SERVICE BULLETIN

PRODUCT PROGRAM BP3 - ANTI-RATTLE KIT

B-010

Figure 1. Updated Drive Pin Assembly

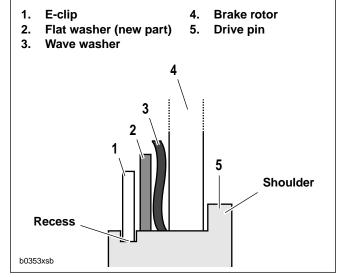
This kit provides an additional flat washer for each front brake rotor drive pin.

See Figure 1. Dealers should inspect all 1997 model year motorcycles in their inventory. For each vehicle without a flat washer (2) installed between the wave washer (3) and E-clip (1), order an ANTI-RATTLE KIT (Part No. 42577-97Y).

- 5. See Figure 1. Install anti-rattle kit components.
 - a. Hold drive pin (5) between rotor and rotor carrier.
 - b. Place a **new** wave washer (3) on drive pin.
 - c. Install a new flat washer (2).
 - d. Install a **new** E-clip (1). Fully seat E-clip using a needle nose pliers. See Figure 4.
